Our Case Number: ABP-317742-23

Re: BusConnects Bray to City Centre Core Bus Corridor Scheme
Bray to Dublin City Centre.

RE: An Bord Pleanála SID Case Reference No KA27.317780

Subject: Bray to Dublin City Centre Core Bus Corridor Scheme Compulsory Purchase Order.

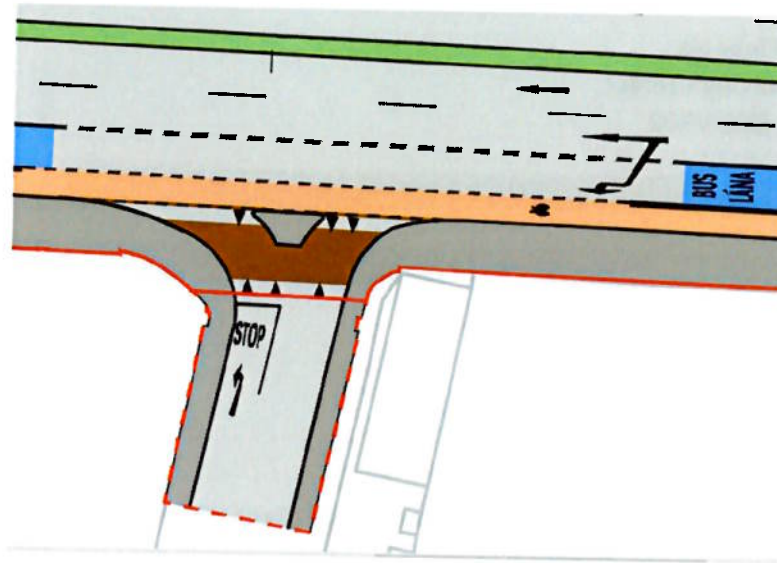
The Works for which the CPO is purported to be necessary would result in the creation of a traffic safety hazard for vehicular access and egress from the Donnybrook Castle development.

The proposal involves the provision of a **STOP** line at a location within the mouth off the entrance where there is no visibility splay to emerging vehicular traffic due to the obstruction posed by the Lodge on the southern side of the mouth of the roadway, as shown in the extract from SHEET 09 of the Scheme

It is submitted that a view to the right is essential in the particular circumstances of this case where egressing traffic is entering onto a major traffic route which is heavily used at all times.

The proposed design is not in compliance with Chapter 4, Section 4.4.6 of DMURS which advises that a visibility splay should be provided at junctions, as extracted below :

Chapter 4 - 4.6.2.2 Pedestrian Crossings

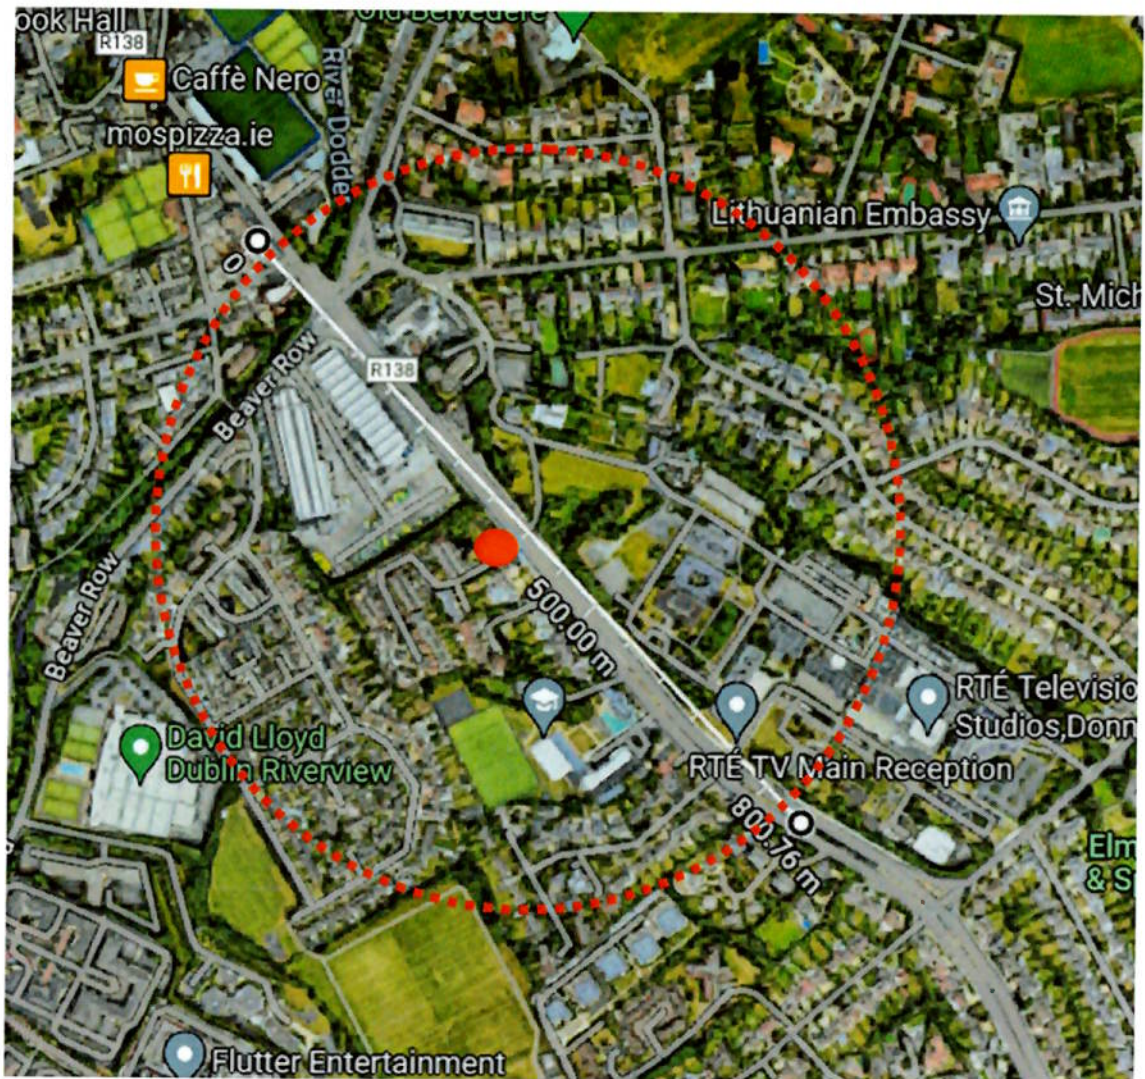
The impact of this structure on the existing junction is shown in the aerial view below, in which the raised pedestrian table is to be located across the full width of the junction and the outer edge will be ramped down to carriageway level on the inner edge of the bicycle lane on the Stillorgan Road.

The provision of a raised table at this location will constitute a significant impediment to the safe use of the junction by ingress and egress traffic.

It is submitted that the provision of this structure is a disproportionate response to the need to facilitate pedestrian crossing requirements at this location.

It is submitted that the provision of a courtesy crossing, as outlined in Chapter 4.3.2 of DMURS, and defined by a change in material alone, will be sufficient in the circumstances of this junction to allow pedestrians to informally assert the required degree of priority over drivers.

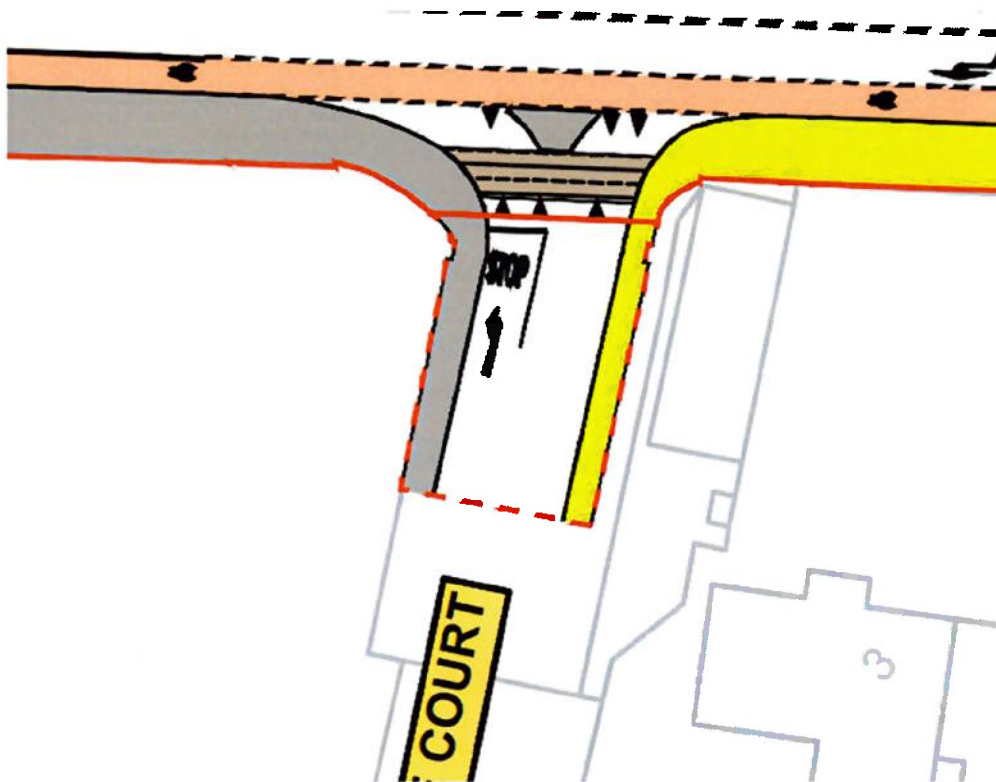
The above aerial view demonstrates that there are no facilities or amenities within the 400m pedestrian radius from the junction. Pedestrian crossing facilities are not provided in the vicinity on the Stillorgan Road.

Accordingly, it can be reasonably concluded that pedestrian travel mode in this area is negligible.

Therefore it is submitted that the use of a raised pedestrian table is not necessary at this location, particularly, where the circumstances cited in DMURS Chapter

4.4.7 for the provision of raised tables do not prevail, and are not advised in the situation which prevails at the junction.

The impact of the scheme is particularly delineated on SHEET 09 Volume 3 Chapter 4 in respect of Landscape, as extracted below:

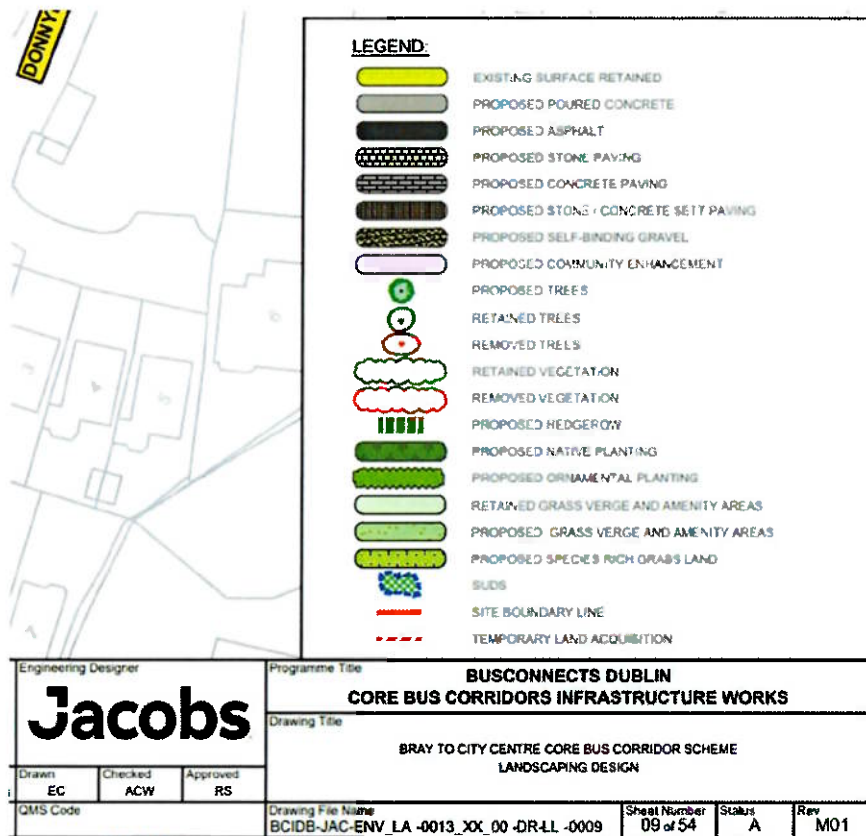
In the first instance, it is to be noted that the layout of the raised pedestrian table is not in agreement with the plan shown in the General Arrangement Section, as abstracted in Section 1 above. It is now shown offline from the 'desire' route, as determined by the existing adjoining footpaths on either side. This layout is contrary to advice in Chapter 4.3.2 of DMURS.

This proposal is further set out in the SHEET 09 Pavement Treatment Plan, abstracted below:

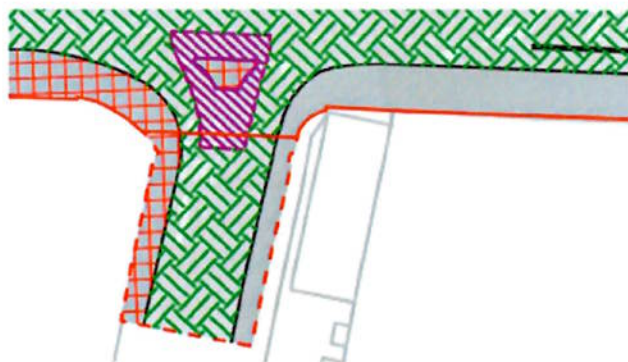
It is clear that the entire area of the 'temporarily acquired' lands are to receive a 'proposed overlay'.

It is submitted that the existing internal footpaths on either side of the junction are in similar satisfactory condition .

The partial renewal of surfaces, as proposed under this scheme, will have a negative impact on the appearance of the entrance to the development and will detract from the value of the property.
